February 25, 2015

City Engineer  
La Crosse, WI

Re: Concrete Alley Paving Between King & Main Street

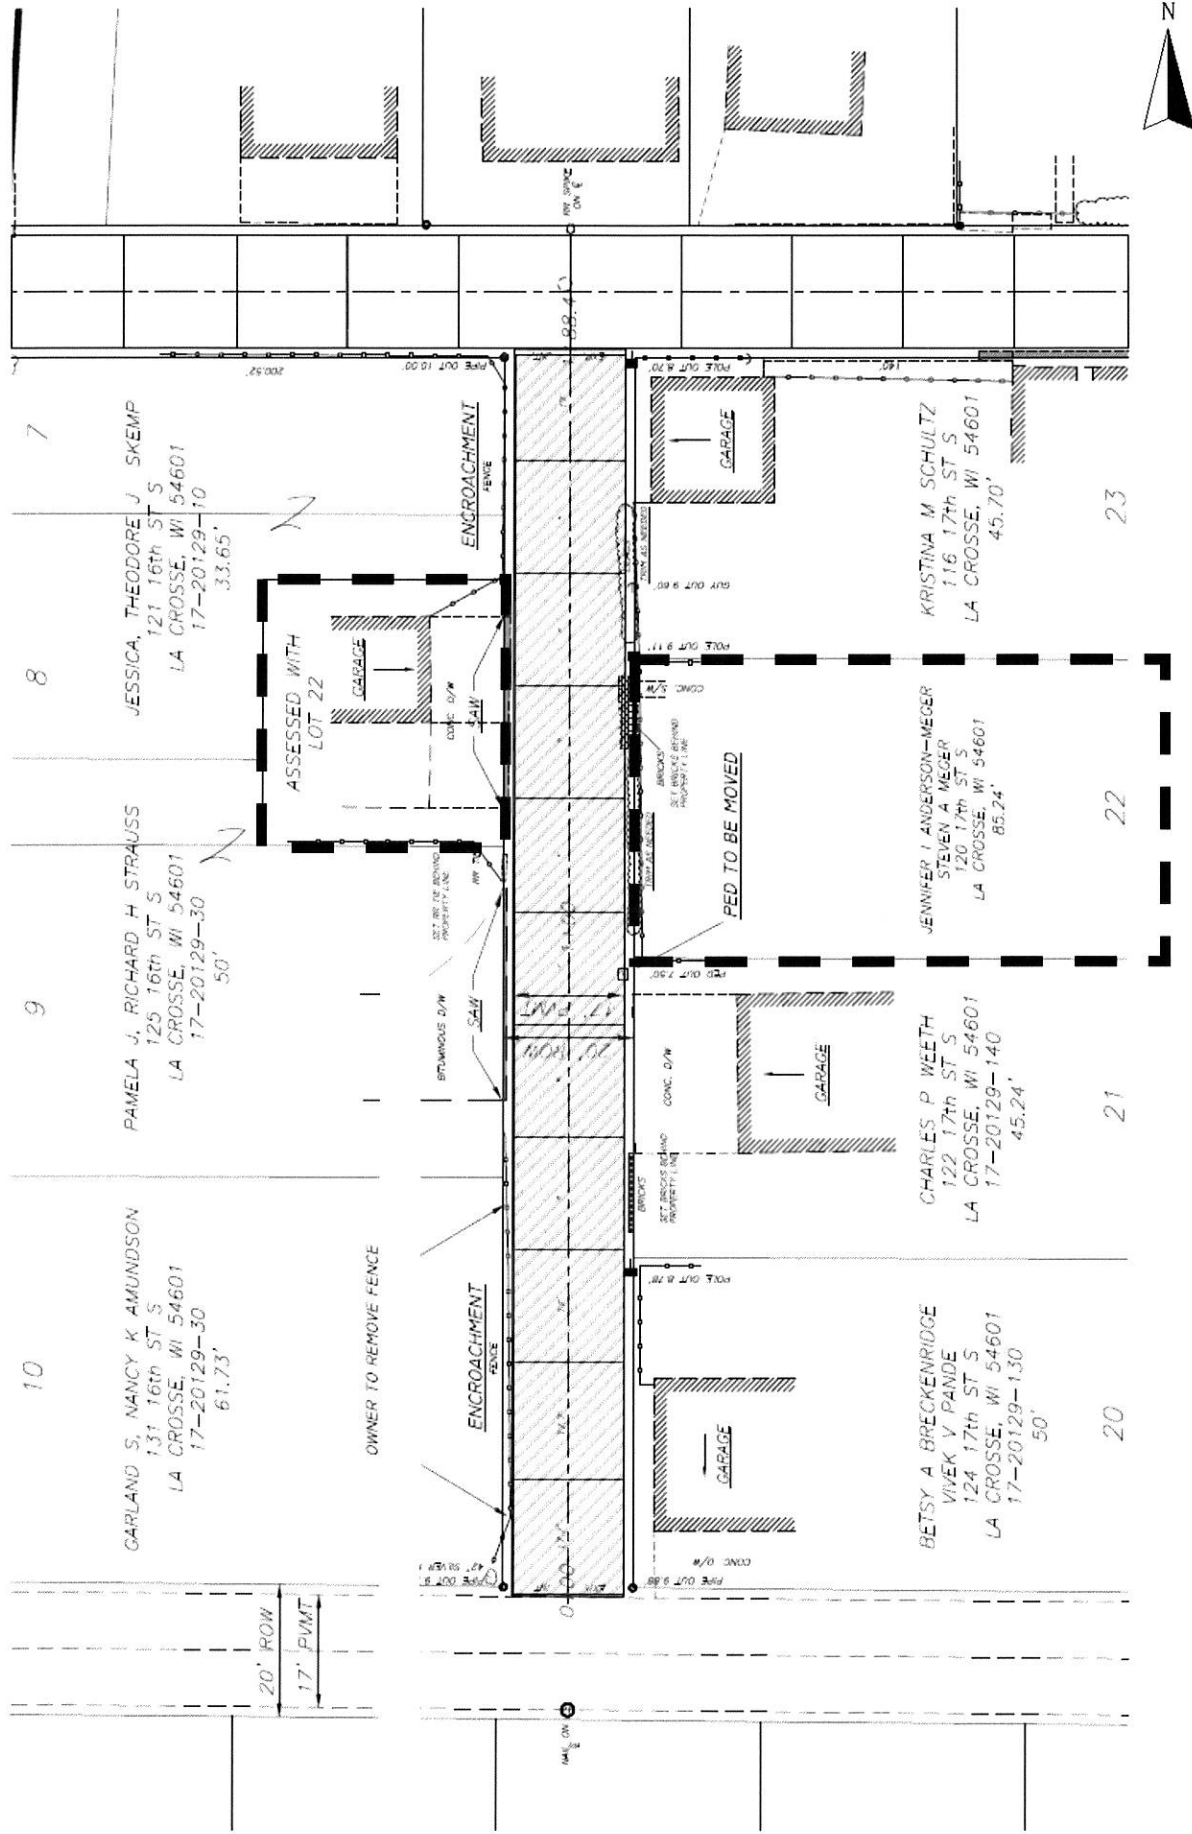
We are residents, taxpayers and owners of the residential property located at 120 17<sup>th</sup> Street South (Lot 22). Due to an atypical alley configuration, an alley runs between our backyard and our detached garage/carport. See attached map. The alley slopes down toward the north through our property.

While we do not object to the project as such, we do register a concern that the paving could induce flooding of our garage/carport. Replacement of gravel with impervious concrete will impede the seepage of rain and melt water, and hasten the travel time. That water has to go somewhere and we hope it won't be our garage and carport. See attached photos.

Therefore, we respectfully request that this concern be fully addressed in the design and construction of this project.
